PRIVATE WATER DISTRIBUTION SYSTEM IMPROVEMENTS

PROJECT NO.
 2132PPW (183021)

AS-BUILT PLANS - OCTOBER 2018

PRIVATE WATER DISTRIBUTION PLANS FOR
TIS - ELC
 THE INDEPENDENCE SCHOOL, WICHITA, KANSAS

WATER LINE 1

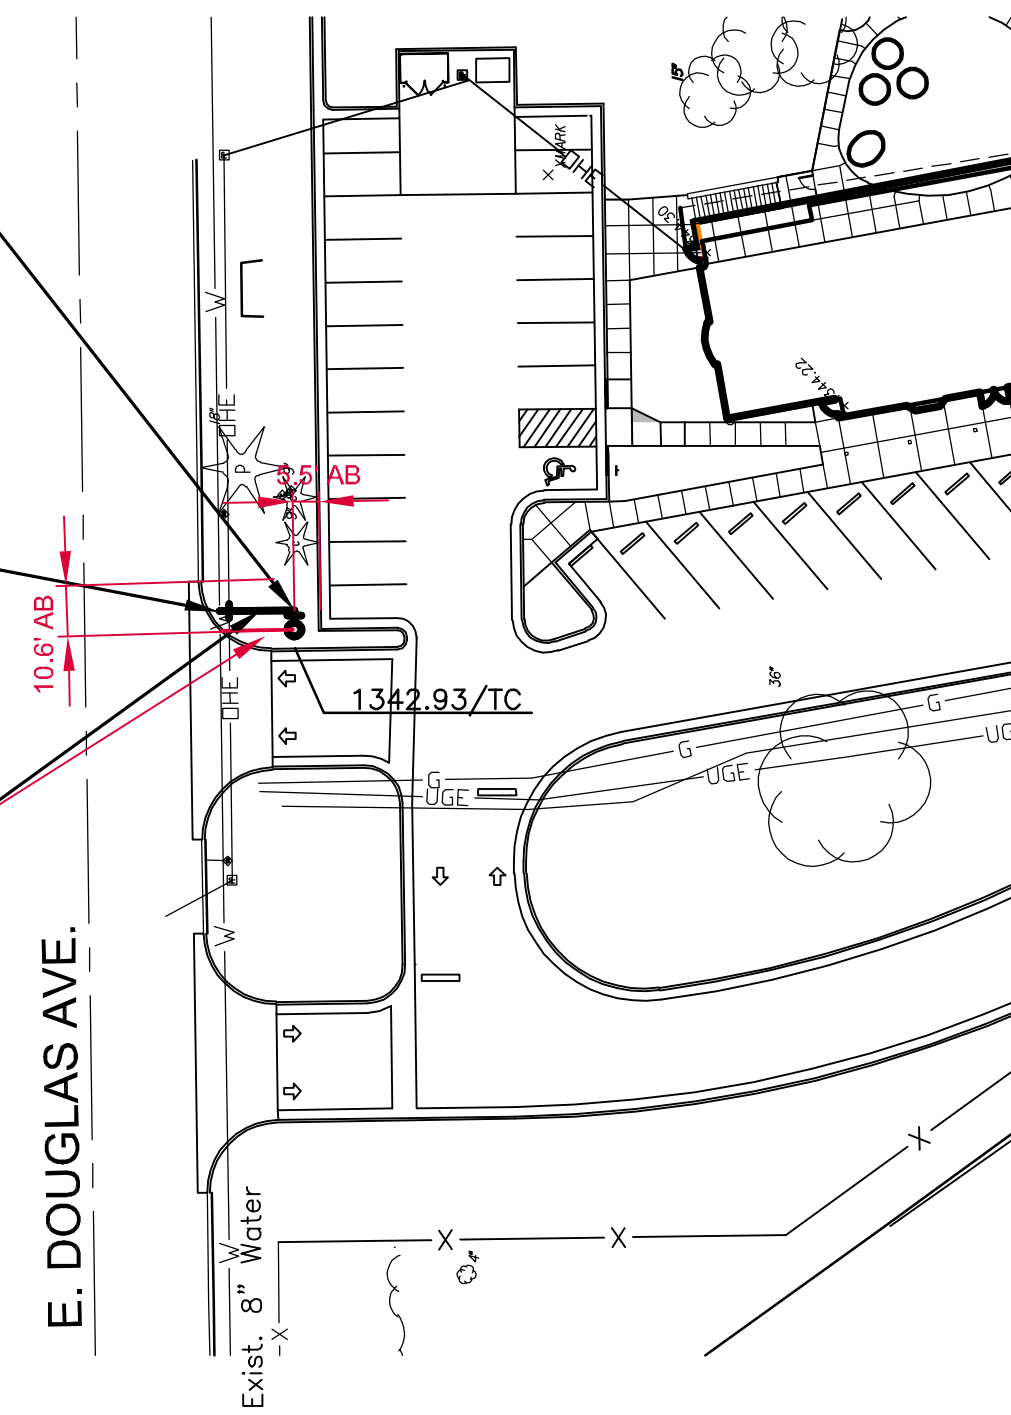
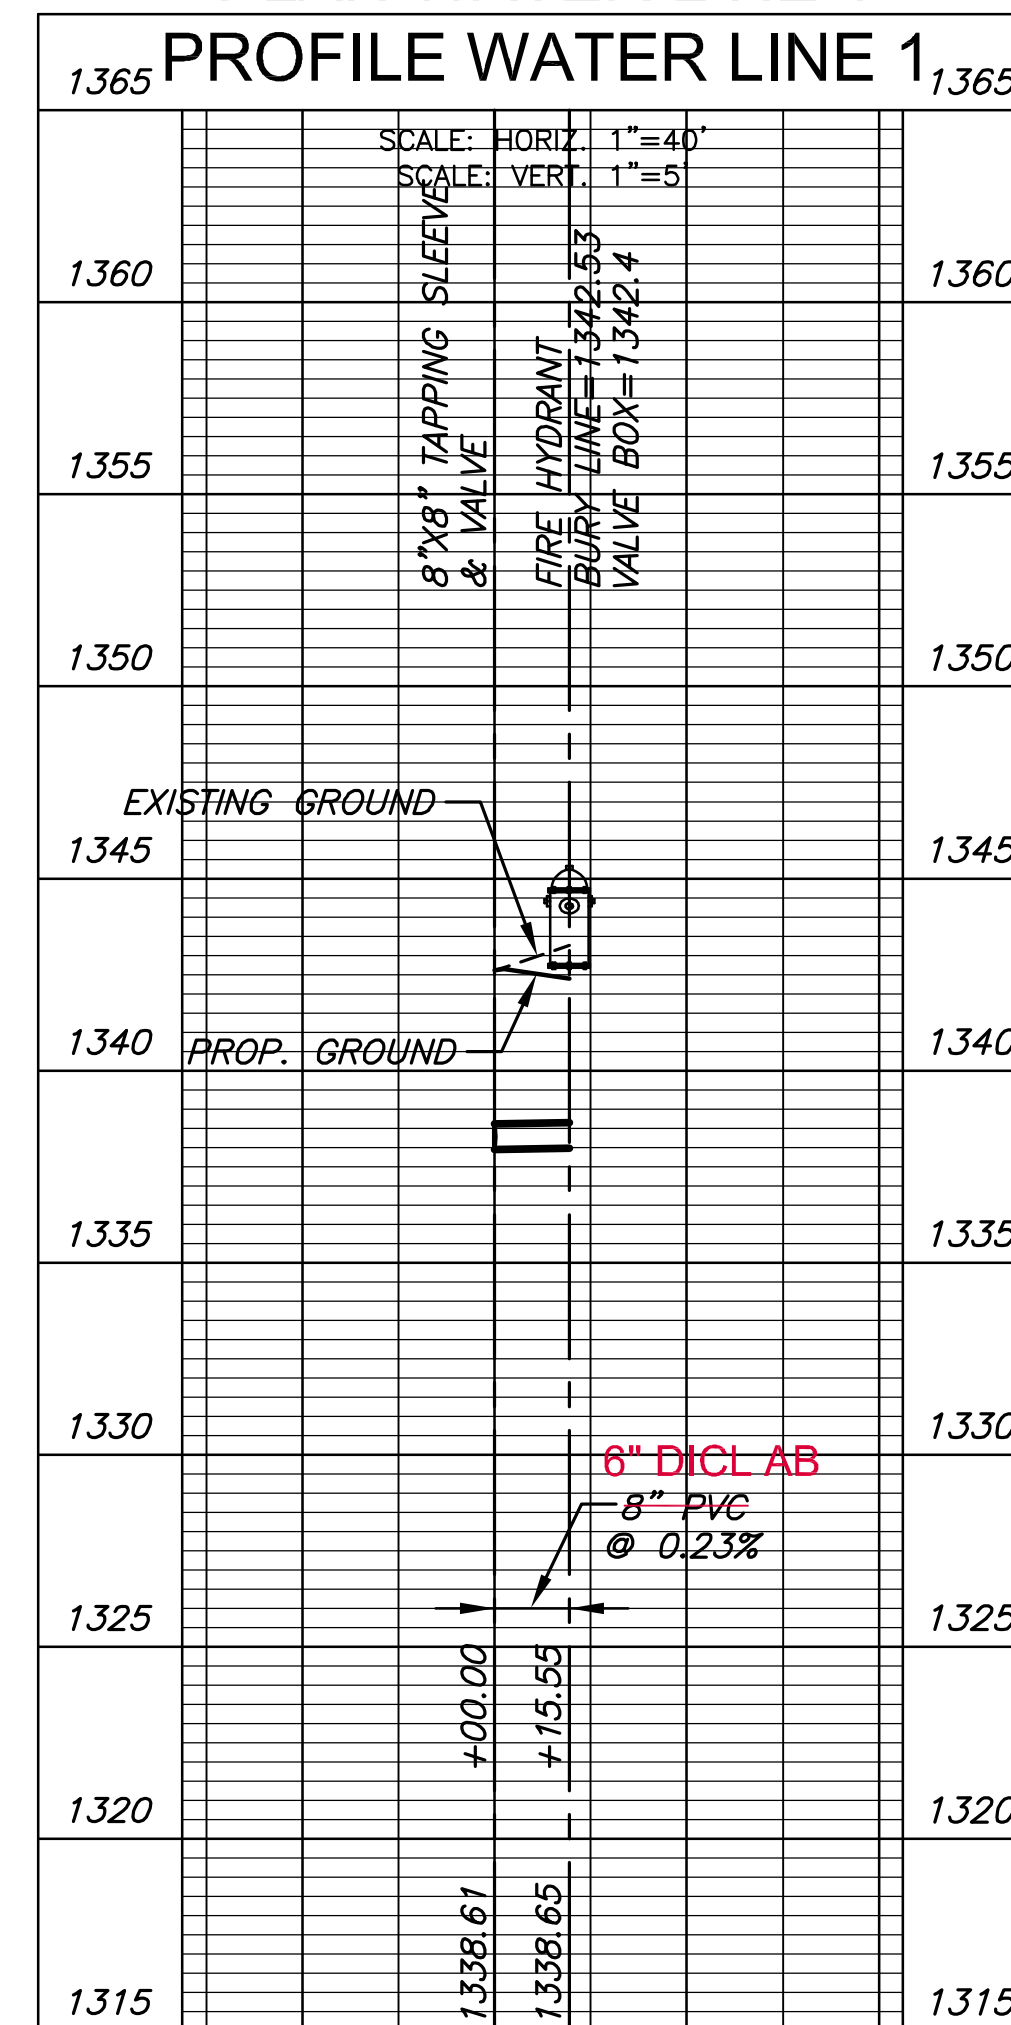
Tap (is in the flowline of south gutter on Douglas) is 24' south of center line of Douglas & 234' east of center line of Longford. FH is 21' south of tap VB.

Water line is in Douglas not behind curb as shown.
